Re: Indian Point Unit No. 2  
Docket No. 50-247

As required by your June 13, 1980 letter which forwarded the NRC Regulatory Staff's interim safety evaluation of the Indian Point Unit No. 2 auxiliary feedwater system, the information regarding items C.1, C.3 and D of that evaluation is provided in Attachments A, B and C, respectively, to this letter. In addition, further information requested by members of the Regulatory Staff regarding auxiliary feedwater automatic initiation, indication, and channelization is provided in Attachment D to this letter.

Basis for Auxiliary Feedwater  
System Flow Requirements  
(Ref: Enclosure 2 of NRC  
November 7, 1979 letter)

Consolidated Edison Company of New York, Inc.  
Indian Point Unit No. 2  
Docket No. 50-247  
August, 1980

Figure 3-1

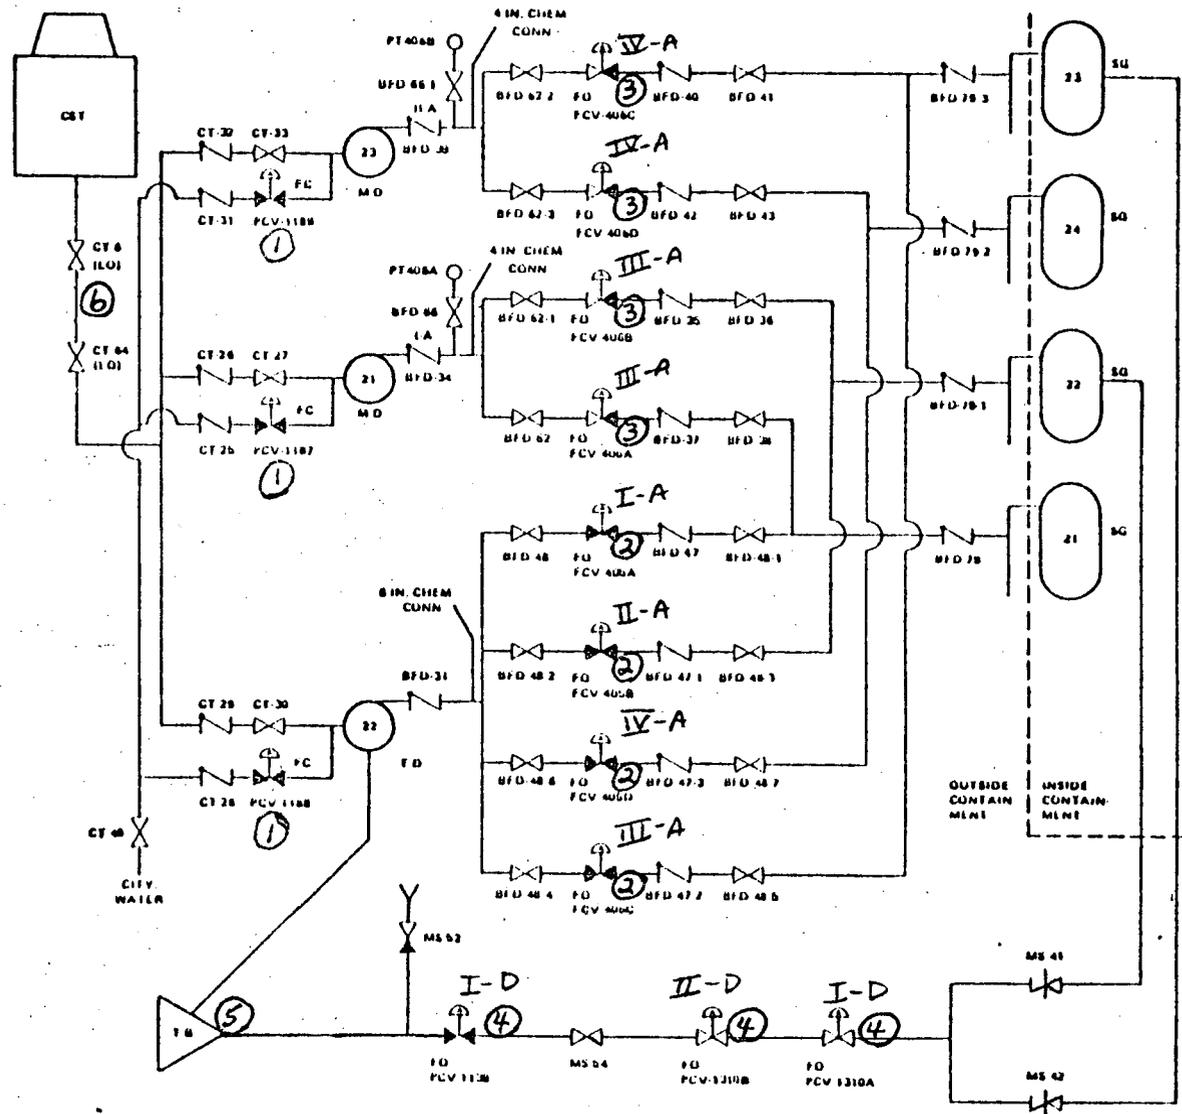
Verify that the AFW pumps in your plant will supply the necessary flow to the steam generator(s) as determined by items 1 and 2 above considering a single failure. Identify the margin in sizing the pump flow to allow for pump recirculation flow, seal leakage and pump wear.

Figure 3-1 schematically shows the major features and components of the Auxiliary Feedwater System for Indian Point Unit No. 2. Flow rates for all of the design transients described in Response 2 have been met by the system for the worst single failure. The flows for those single failures considered are tabulated for the various transients in Table 3-1, including the following:

There is approximately 15% margin for the turbine-driven auxiliary feed pump which allows for a continuous recirculation flow and bearing cooling flow, as well as any seal leakage and pump wear. The motor-driven auxiliary feed pumps do not utilize pump discharge flow for bearing cooling. Also, the recirculation flow path is automatically isolated when pump flow increases above 55 gpm (maximum recirculation flow), thus providing flow only to the steam generators at design conditions. Pump wear and seal leakage are considered to be negligible.

Table 3-1 includes the effect of throttling of the auxiliary feedwater system. As can be seen in all cases the minimum flow requirement of 400 gpm is clearly exceeded.
